- 1. Bunnell's Subdivision 2023 Replat; KPB File 2023-047
Ability Surveys / Malone, Hendrix
Location: Swatzell Street & West Pioneer Avenue
City of Homer**

**BUNNELL'S SUBDIVISION
2023 REPLAT**

STAFF REPORT

Staff Report 23-025

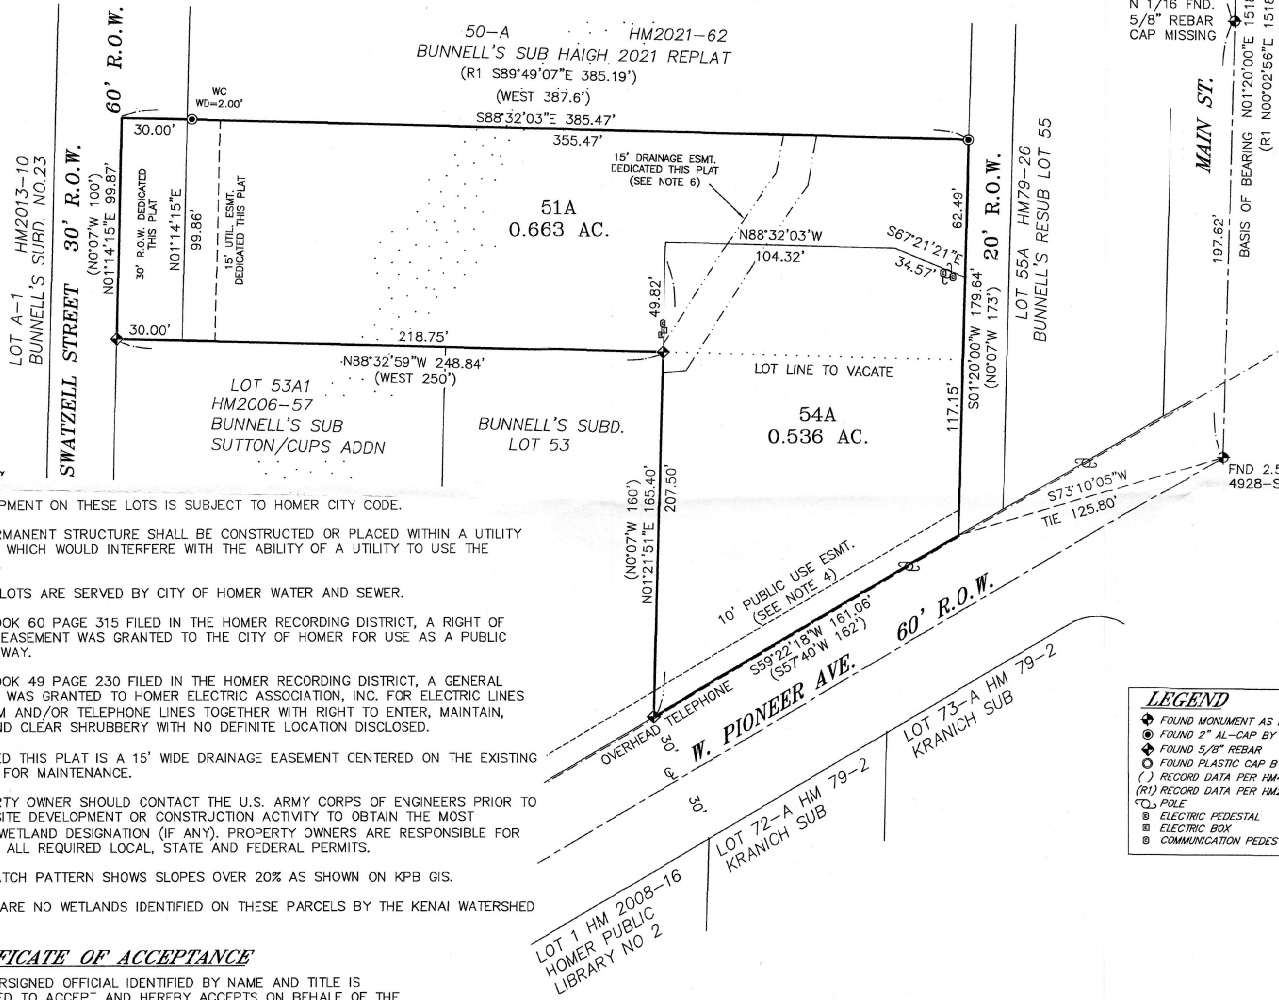
Site Investigation: The terrain is flat near Swatzel Street and then drops along a slope to the east towards the natural drain way in the back of proposed Lots 51A and 54A. Then the terrain is relatively flat draining towards W Pioneer Ave. The City of Home has requested a 15 foot drainage easement be added along the drain way. **Staff recommends:** adding the drainage easement to the *Certificate of Acceptance*.

There is a proposed 15 foot utility easement proposed along the dedication for Swatzel Street as shown on the subdivision drawing. **Staff recommends** adding the 15 foot easement to W Pioneer Ave side of Lot 54A.

Staff recommendation: Add “City of Homer” to the title block.

Staff recommendation: Label adjacent alley “Alley”

- D. A vicinity map, drawn to scale showing location of proposed subdivision, north arrow if different from plat orientation, township and range, section lines, roads, political boundaries, and prominent natural and manmade features, such as shorelines or streams;
Staff recommendation: *Label where Pioneer Avenue end and East End Road begins.*

Staff recommendation: *place the standard note on the plat for the flag lot(s): No structures are permitted within the panhandle portion of the flag lot(s).*

Staff recommendation: *comply with 20.60.110. there is a difference in the north south distances originating near W. Pioneer Ave, verification is needed of the distances and pins along the right-of-way.*

- *"No access to state maintained rights-of-way permitted unless approved by the State of Alaska Department of Transportation."*

Staff recommendation: *Add the 15-foot drainage easement to the certificate of acceptance and comply with 20.60.190.*

1. There will need to be a drainage easement that continues from Lot 50-A.
2. Dedicate a 15' drainage easement centered on the creek of Lots 51A and possibly through the north west corner of lot 54A.
3. Dedicate a 15' utility easement fronting the newly dedicated Swatzell Street.
4. There currently exists a water and sewer stub out for lot 51A on the south east property boundary. These services will need to be relocated north as to serve the lot directly and not via an easement.
5. The property owner will need to relocate the services prior to recording the plat, or enter into an installation agreement with the City, in which they will bond the cost of relocating the services in an agreed upon time frame. This will allow the plat to be recorded prior to the work being completed.

1. Include a plat note stating "Property owner should contact the Army Corps of Engineers prior to any on-site development or construction activity to obtain the most current wetland designation (if any). Property owners are responsible for obtaining all required local, state and federal permits."

2. Dedicate a 15' drainage easement centered on the creek of Lots 51A and possibly through the north west corner of lot 54A.
3. There currently exists a water and sewer stub out for lot 51A on the south east property boundary. These services will need to be relocated north as to serve the lot directly and not via an easement.

4. The property owner will need to relocate the services prior to recording the plat, or enter into an installation agreement with the City, in which they will bond the cost of relocating the services in an agreed upon time frame. This will allow the plat to be recorded prior to the work being completed.
